**SITE PLAN REVIEW**

<b>Owner: Bernard A. Giroux Trust, June T. Giroux Trust, Victor J. Giroux Trust and Ramona M. Giroux Trust.</b>	<b>Applicant: Tyler Sterling for Hannaford Bros. Co.</b>
<b>Surveyor/Engineer: O’Leary Burke Civil Associates 1 Corporate Drive Essex Jct. Vt.</b>	<b>Property Tax Parcel: 20-50-02.200</b>

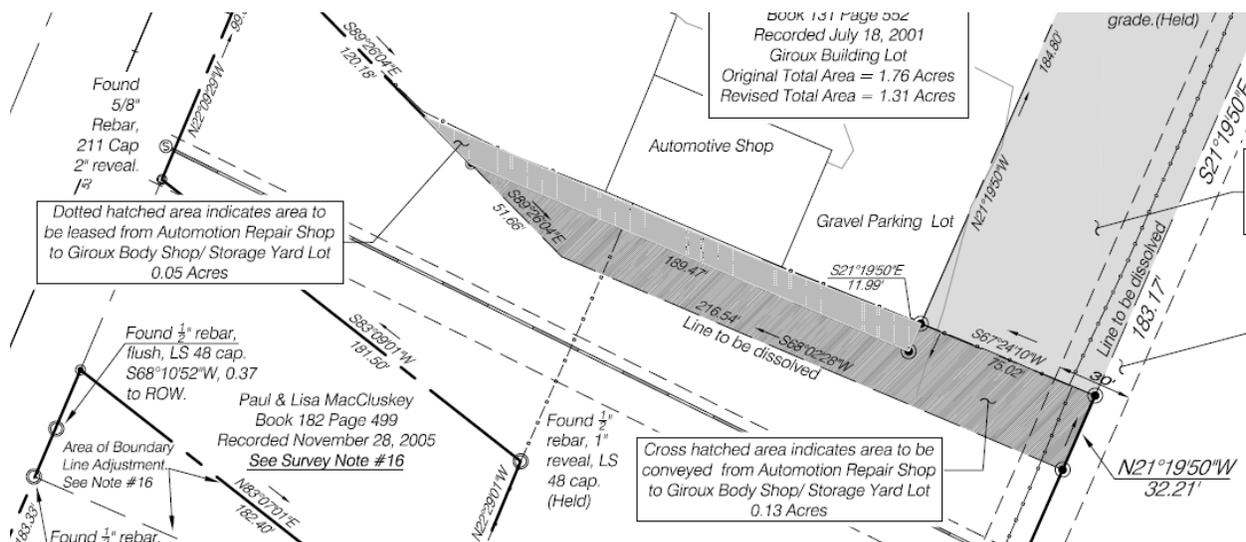
***1) Safety of vehicular and pedestrian circulation on site and on the adjacent street network.*** It appears adequate if all the conditions included in the 2005 relating to the driveway and curbcut are included in this approval

**addressed where applicable.** No apparent issues except refuse storage and disposal - see landscaping

**3) Adequacy of landscaping, screening, setbacks, hours of operation and exterior building design in regard to achieving maximum compatibility with adjacent property and with the character of the neighborhood.** The character of the neighborhood has changed with the approval of the Farmers Market which will be directly adjacent to and above the rear yard of this business. While there is screening included on the Hannaford Site Plan, it may not be adequate to insure that the view from this public facility doesn't include unscreened refuse. Currently there are piles of tires, barrels etc. and not slightly.

Finding #5 of the 2005 approval addressed the cedar trees as "existing trees". Landscaping budget credit for moving them may not be appropriate. In any case the proposal for their relocation to the northern boundary of the property is in contradiction of Conclusion #3 of the 2005 decision which stated that no additional landscaping was necessary there because it was the back of firehouse plaza. There might be a better location for them, possibly screening front yard parking or to bolster the screening between the Farmers market which will be five feet above and adjacent to the rear of this property.

**6) Adequacy of drainage and grading plan, ensuring treatment and control of stormwater runoff, control of soil erosion during and after construction, and proper design solutions for steep slopes and poorly drained areas.** Finding # 10 from the 2005 approval stated that: the rear portion of the property drains to a swale at the rear of the property, which flows north under commerce street and eventually to Patrick brook. The front portion of the property drains to the Vt. Route 116 drainage ditch, and then north to Patrick brook (well beyond the property). The construction of the platform for the farmers market will isolate this property from direct access to above mentioned swale. The submitted site plan appears to allow some concentrated flow across the north east corner of this property into the swale; however it is difficult to confirm this from the submitted plans. The stormwater that does currently flow from this site to the east into the existing, uncovered swale receives flow control and treatment from the more than 60 feet of grassed surface available between the existing gravel area and the center of the open vegetated swale extending the full width of the lot. This will all be eliminated and this must be addressed.

As well no stormwater treatment is proposed for the increase in impervious surface for the rest of the increased parking area.
